**ZONING AMENDMENT &  
SUBDIVISION STAFF REPORT****Date: October 20, 2005****NAME**

**SUBDIVISION NAME**Shannon Heights Subdivision, First Addition, Resubdivision  
of a Portion of Lots 18, 19, 20, and 21**LOCATION**2648, 2650, and 2652 Government Boulevard  
(Northwest corner of Government Boulevard and Merwina  
Avenue, extending to the South side of Kreitner Street at its  
West terminus)**CITY COUNCIL  
DISTRICT**

APPLICATION NUMBER Holdover DATE November 17, 2005  
APPLICANT White-Spunner & Associates (Nancy Stone, Agent)  
REQUEST Rezoning from R-1 to B-2 and Subdivision

# SITE PLAN

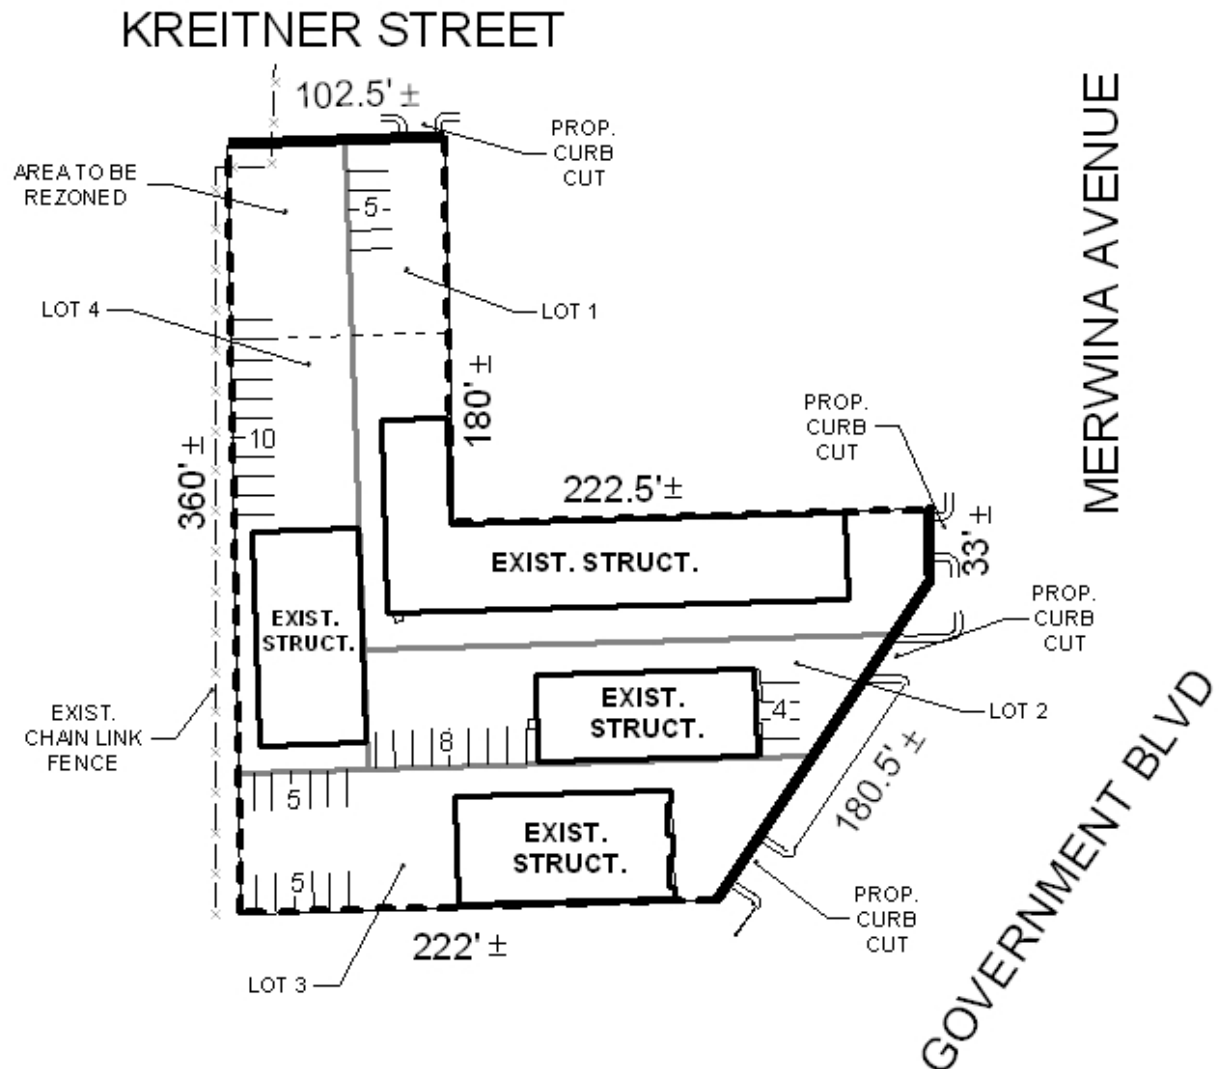
The site plan illustrates the existing buildings, which are proposed to remain, as well as proposed parking. Seven of the required parking spaces for proposed Lots 3 and 4 are located in the right-of-way, and thus would not satisfy the parking requirements. It is also unclear how the four spaces for proposed Lot 1 (the portion near Kreitner Street) would be accessed, since no curb cut is proposed to Kreitner Street. As the applicant does not desire Planned Unit Development approval, access to these spaces on Lot 1 would be denied from Lot 4. For the same reason, all vehicular access between the various lots should be denied.

The applicant has chosen not to submit a Planned Unit Development application, to allow for shared parking and access. Therefore, the site plan should illustrate that each lot is self-contained, with adequate parking and maneuvering facilities, and individual curb cuts. Physical separation between the lots would also be required to ensure the self-containment of the lots, and the right-of-way should not be used for backing out or parking. The current site plan shows seven of the required parking spaces located in the right-of-way, does not appear to have adequate room within each lot for maneuvering, and does not show sufficient curb cuts to access parking without encroaching on neighboring lots. If the standards for parking and maneuvering cannot be met, an Administrative Planned Unit Development application will be required to address shared access and parking.

*These applications were held over from the October 20<sup>th</sup> meeting to allow the applicant to submit a revised site plan illustrating adequate parking provisions. The revised plan removes the parking spaces from the right-of-way, but still poses issues of maneuvering, and backing into the right-of-way. It does not appear that proposed Lots 1, 2, and 3, as presently developed, can satisfy the requirements for aisle width and maneuvering, as outlined in Section VI of the Zoning Ordinance. However, as noted in the previous report, these issues could be addressed with shared parking and access, by submitting an Administrative Planned Unit Development application.*

*Traffic Engineering submitted the following comments on the revised plan: "Minimum driveway width for commercial drives with two way traffic is twenty-four feet. Changes should be made to accommodate this width. The parking spaces in front of the buildings on lots 1, 2, and 3 do not have adequate space for maneuvering and should be eliminated. Drives to access rear parking stalls are less than the minimum width required for two-way drives. Changes should be made accommodate the minimum width of twenty-four feet. Traffic Engineering also has some concern of the locations of the proposed driveways on Merwina Avenue and Government Boulevard, which appear to be located*

*at the intersection of the two roads. This site may be better served by the use of shared driveways and parking which will allow for one-way traffic flows and one-way driveways.”*

*Subdivision Based on the preceding, with a waiver of Section V.D.2 (minimum dimensions) and V.D.3 (maximum depth), the plat would meet the minimum requirements of the Subdivision Regulations, and is recommended for Tentative Approval, subject to the following conditions: 1) the depiction of the required 25-foot building setbacks on the final plat; 2) the illustration of 50-foot building setbacks, measured from the centerline of the planned major street (Crosstown Loop 4 New Connection); 3) the completion of the rezoning process, to correct the split-zoning on the site.*

*Rezoning Based on the preceding, this application to rezone the site to B-2, Neighborhood Business, is recommended for approval, subject to the following conditions: 1) full compliance with the frontage tree requirements of the Zoning Ordinance along Kreitner Street, to be coordinated with Urban Forestry; 2) submission and approval of an Administrative Planned Unit Development application for shared parking and access; and 3) full compliance with all municipal codes and ordinances.*
